DAIMLERCHRYSLER

Safety Recall B34 – Valve Cover Stud

2004 (DR) Dodge Ram Pick-up Trucks

Figure 1

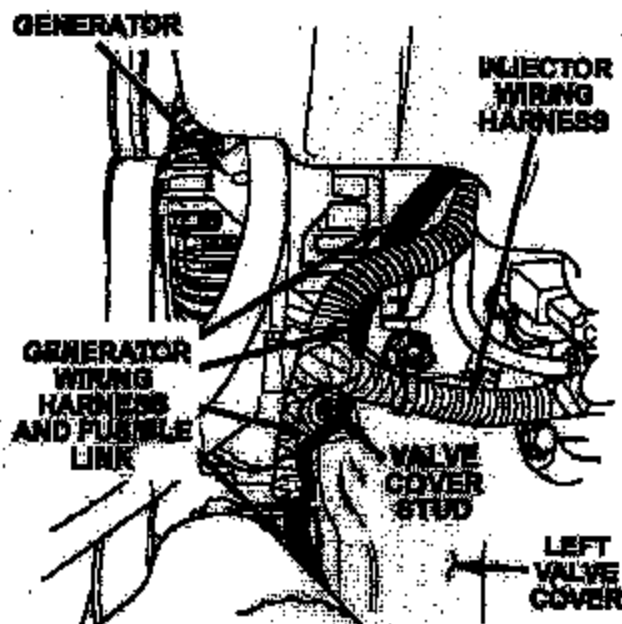
The generator wiring harness on about 2,200 of the above vehicles may short circuit due to contact with a valve cover stud. A short circuit in the generator harness can cause an underhood fire.

1. Open the hood.
2. Inspect the generator wiring harness/fusible link where it passes the valve cover stud located on the front left corner of the engine (Figure 1). If the wiring insulation is damaged from contact with the stud, wrap it with high quality electrical tape.
3. Install the stand off portion of the provided tie strap over the stud on the left front corner of the valve cover (Figure 2).
4. Pull the generator wiring harness forward and position it above the injector wiring harness. Secure the generator harness/fusible link to the injector harness with the provided tie strap (Figure 2).

The generator wiring harnesses must be rerouted and secured to the valve cover stud.
